MEMORANDUM

TO: Katrina Morgan – Community Facilities, Auckland Council
FROM: Stacy Colyer – GreensceneNZ Limited
DATE: 14th April 2016
SUBJECT: Western Springs Pine Tree Removal Project Methodology
– General Comments & Recommendations

Photo No.1: Example of an Eco Pile

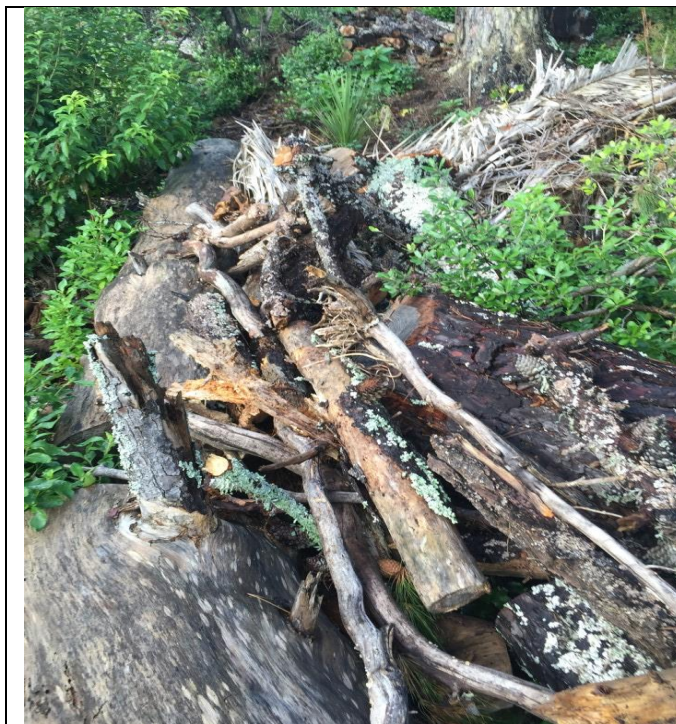
Having reviewed the above methodology, I am of the opinion that the proposed method of 'getting the trees on the ground' (primarily by way of sectional dismantling) would cause significant damage to the existing native vegetative understory throughout the site. I am also of the opinion that the amount of debris created from dismantling an estimated 200+ pine trees growing within the subject site would be staggering. It is also reasonable to suggest that leaving this amount of debris (stacked in eco piles or not) would present a sizeable fire risk as the resulting debris dries out.
